ADDENDUM NO. 2

Issued by: Sacramento City Unified School District

Project: Project #: 0029-401 Bret Harte Playground

| DSA STAMP | |
|--|--|
| DETAILS AND SECTIONS | |

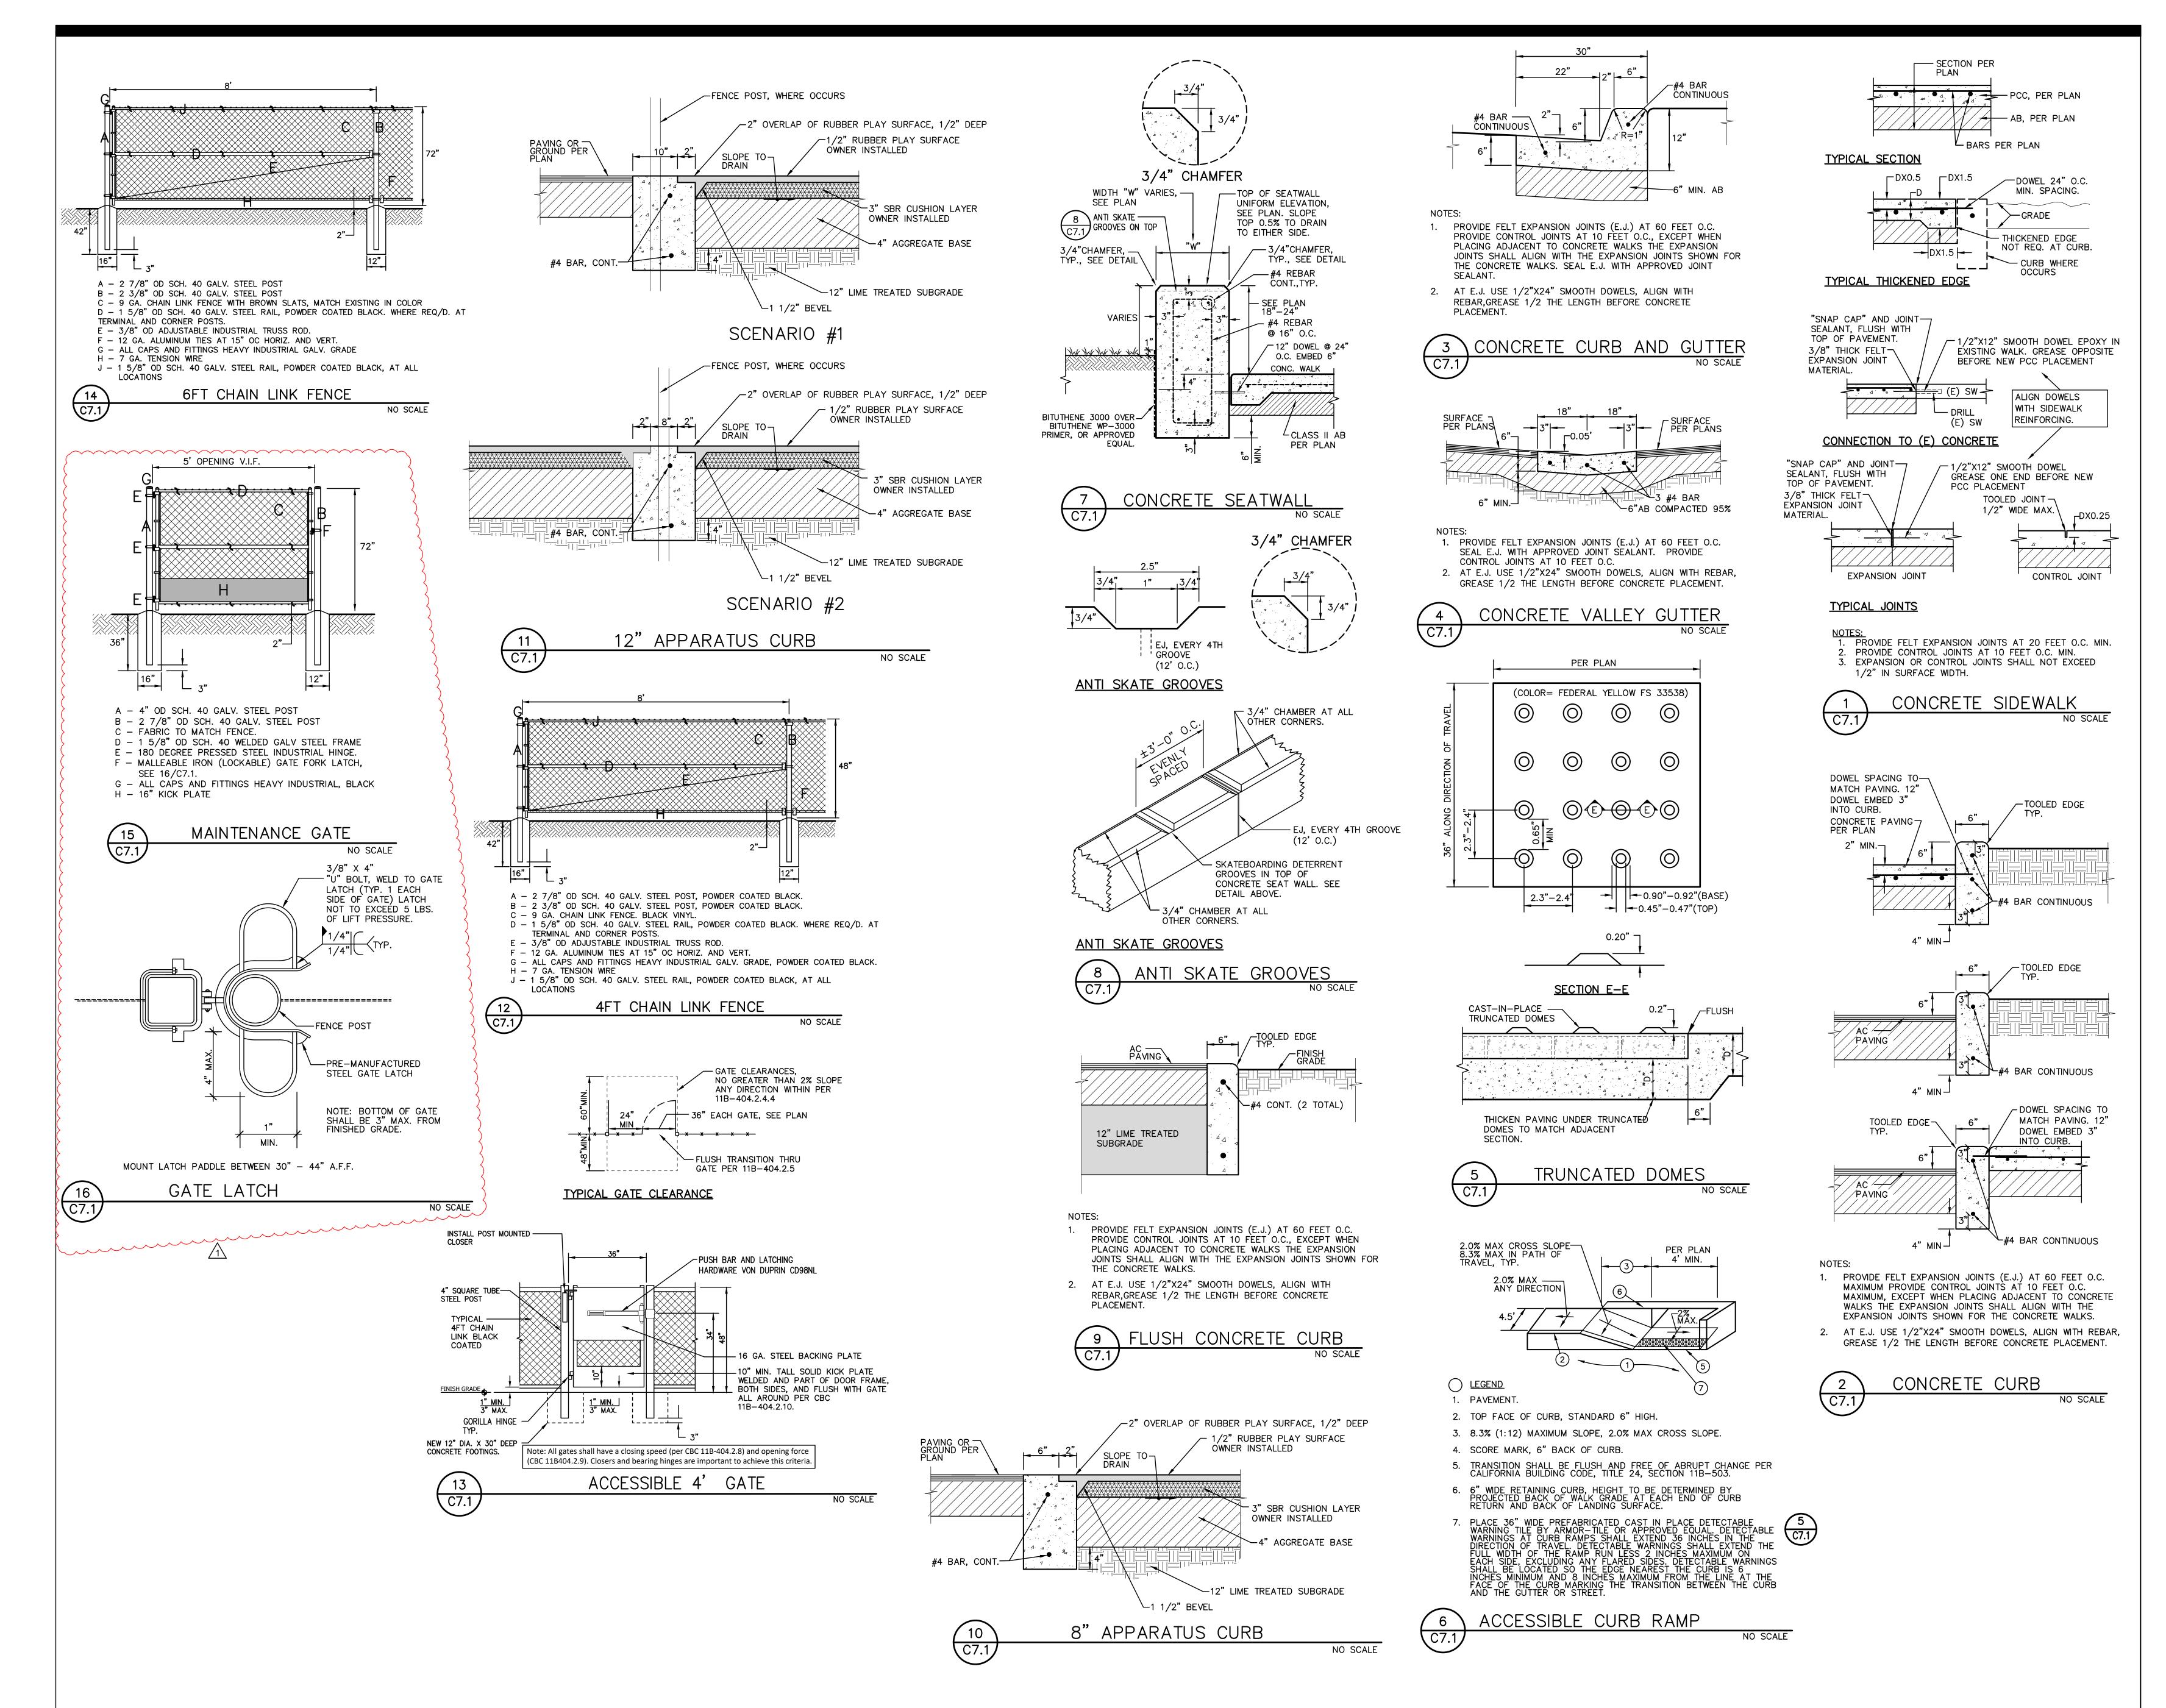
- L. SHEET C7.1:
 - 1. Add detail 16 to sheet
- M. SHEET C7.3:
 - 1. Details #5 and #7:
 - a. Add note "(1) coat grey primer, (2) coats yellow paint, commercial grade" and add dimensions per detail #10

| DSA STAMP | |
|--|---|
| DETAILS AN SECTION | S |

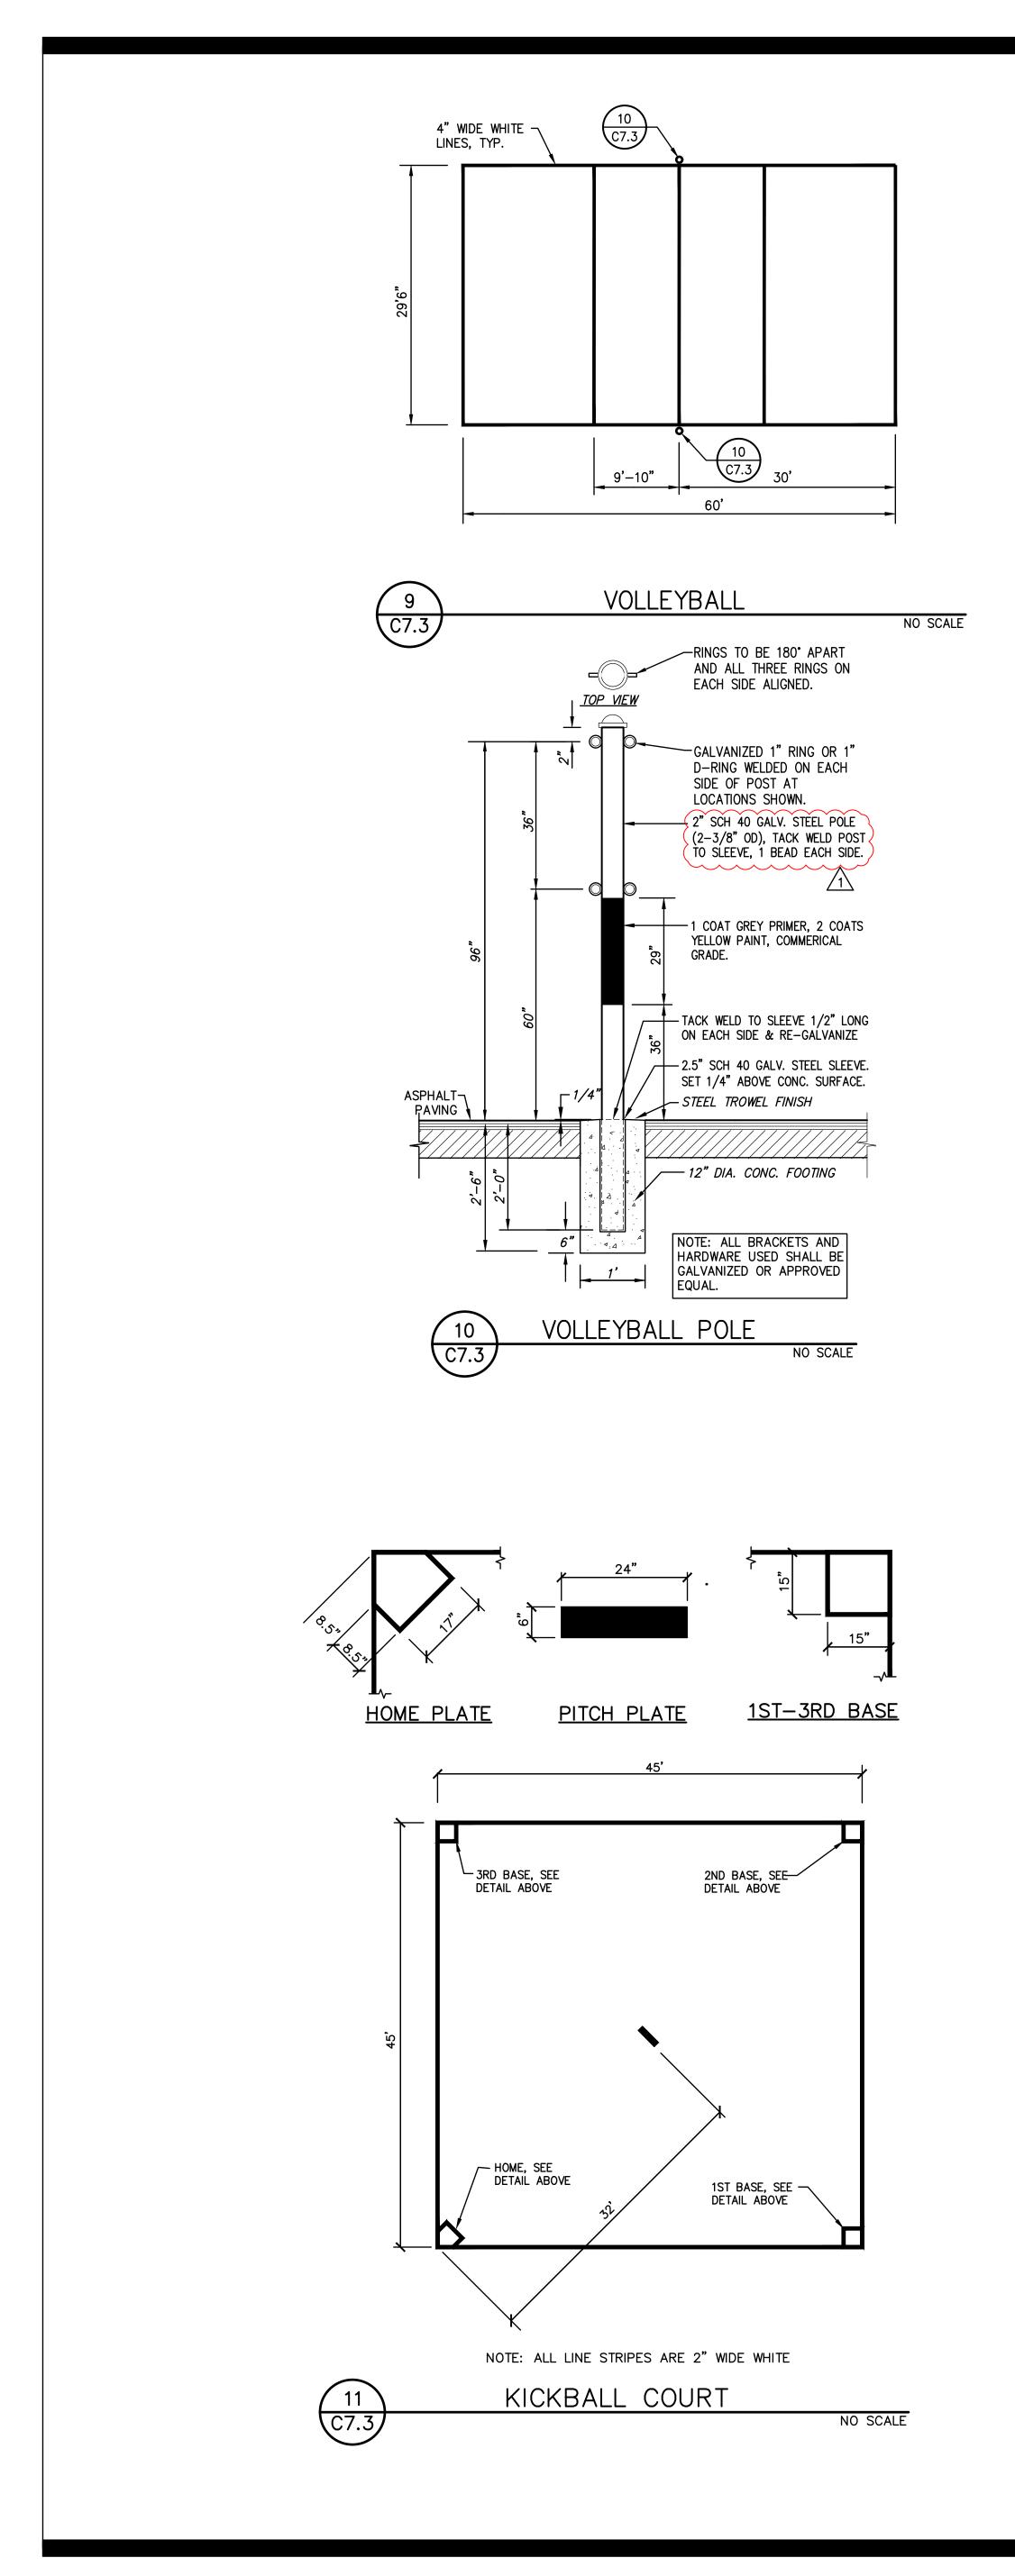
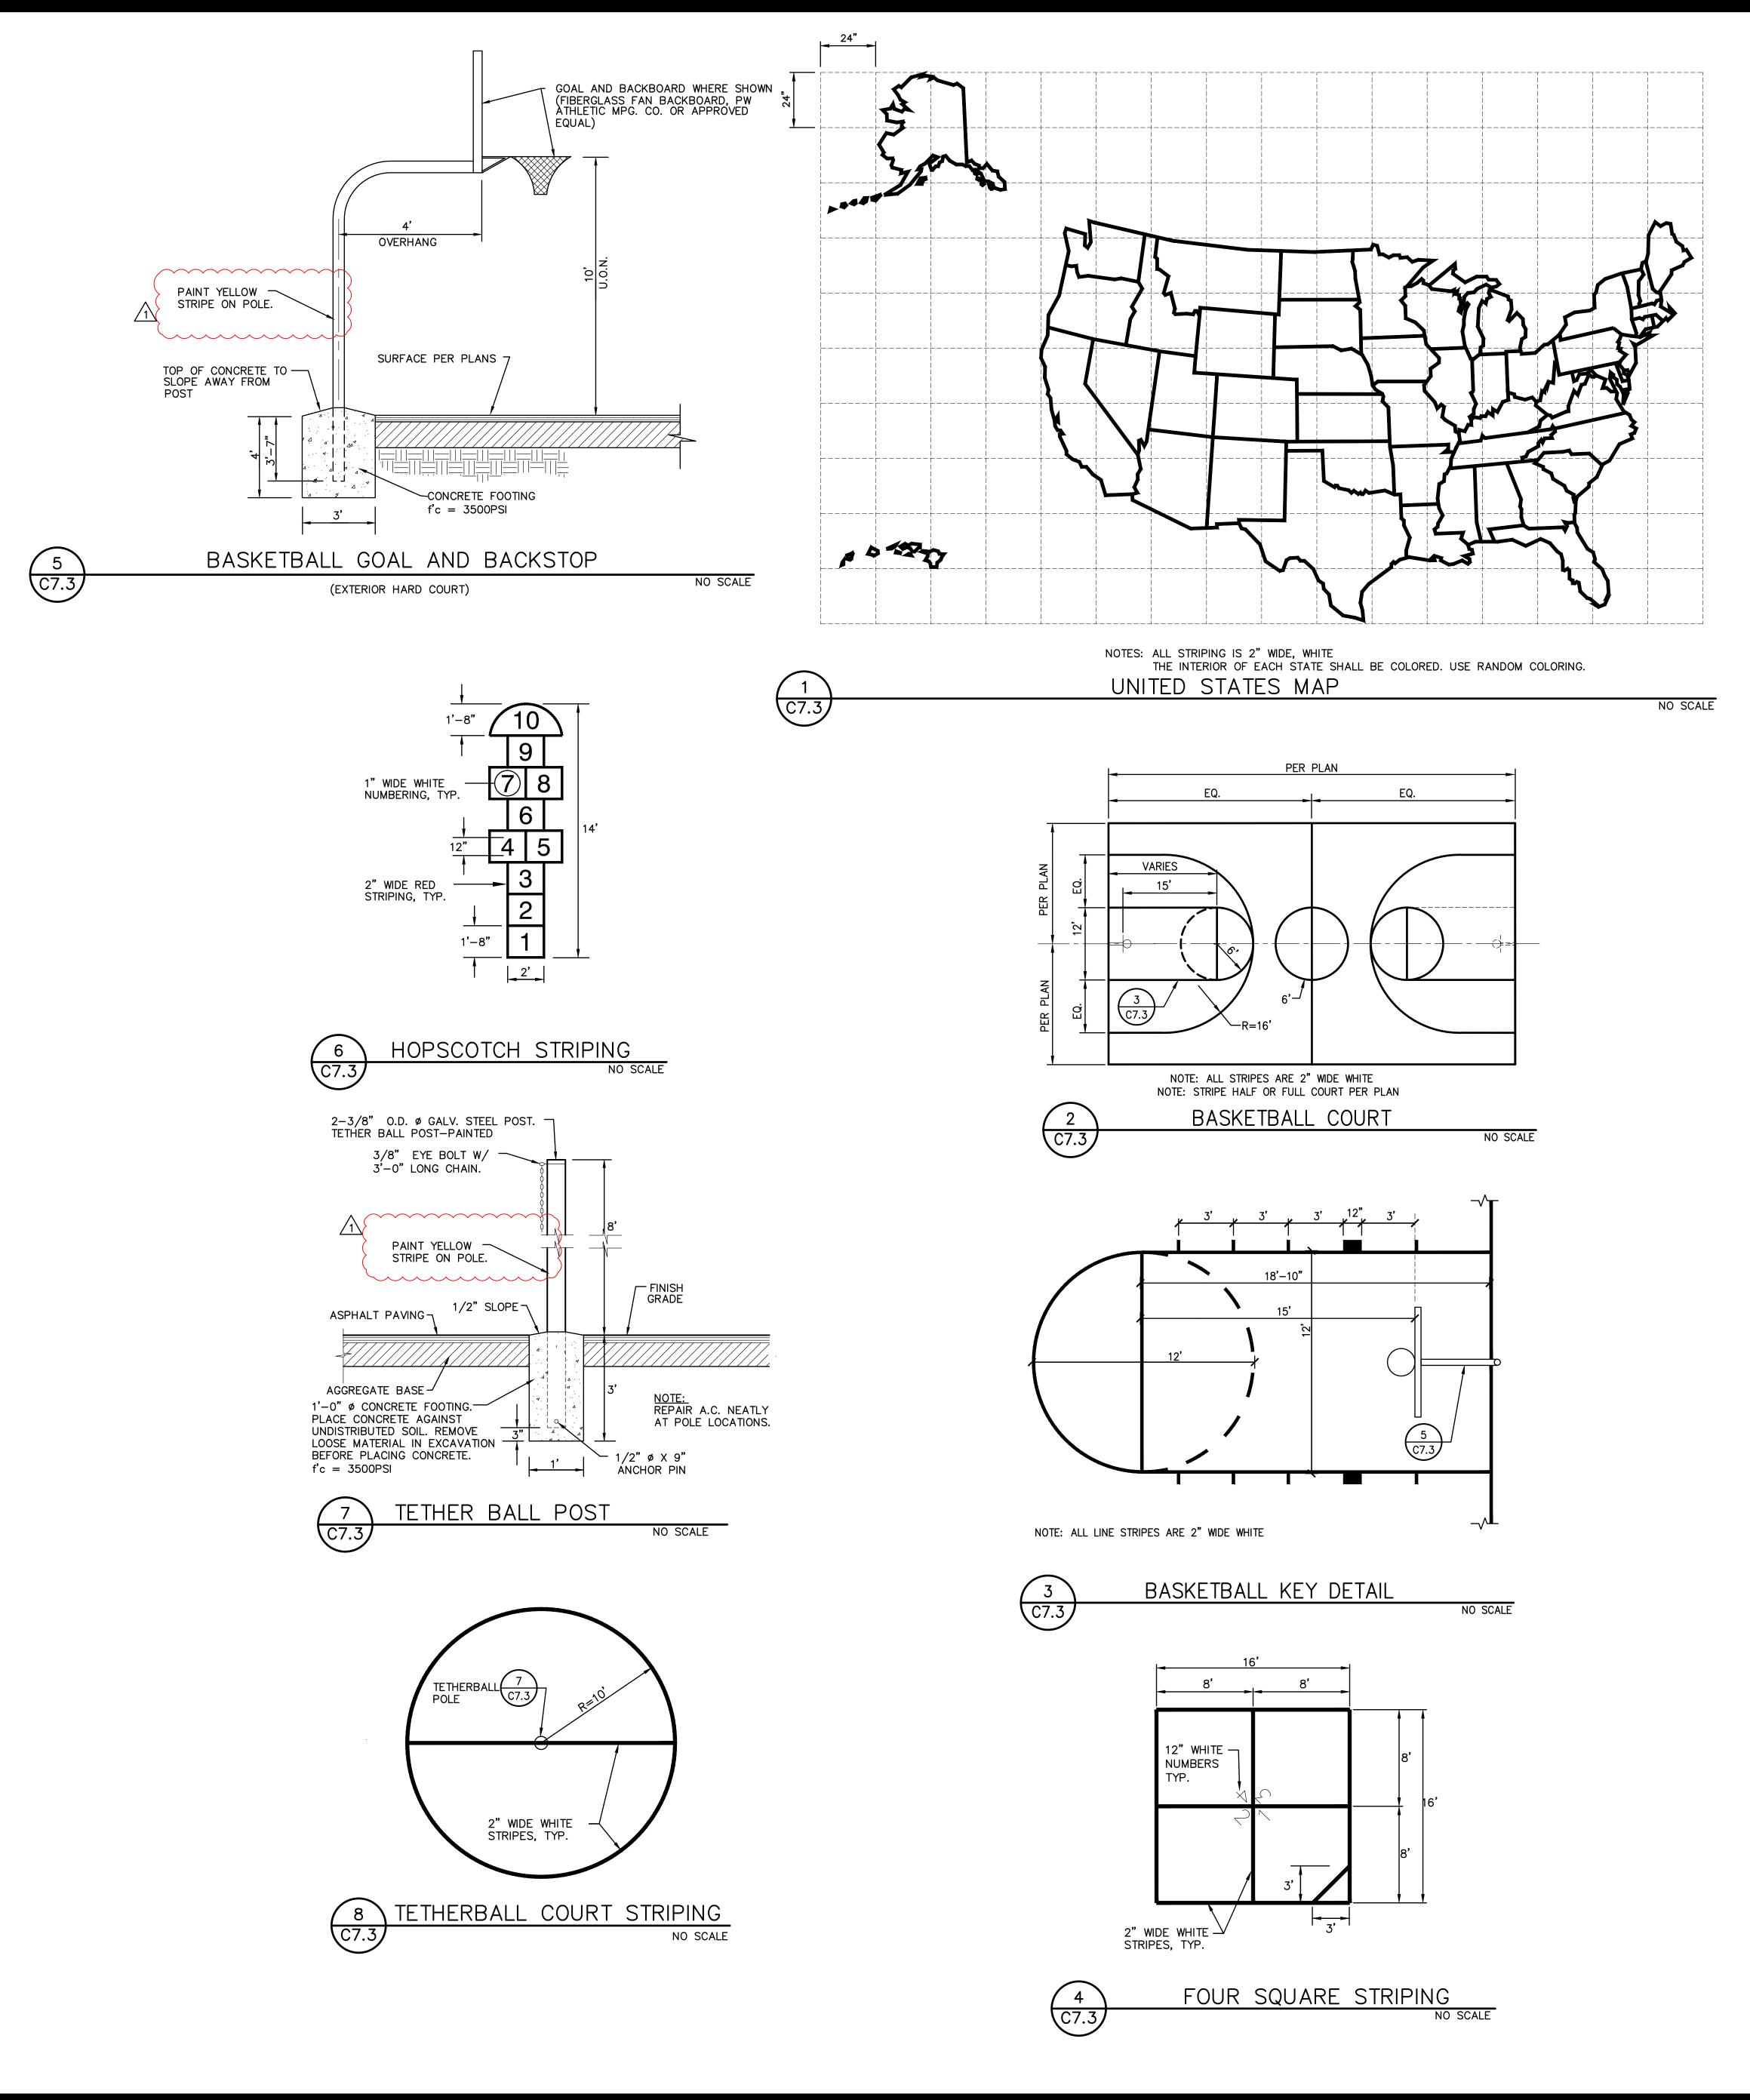
- 2. Details #7 and #10:
 - a. Revise note "2" SCH 40 Galv. Steel pole (2-3/8" OD) painted white. Tack weld post to sleeve, (1) bead each side" to "2" SCH 40 Galv. Steel pole (2-3/8" OD). Tack weld post to sleeve, (1) bead each side"
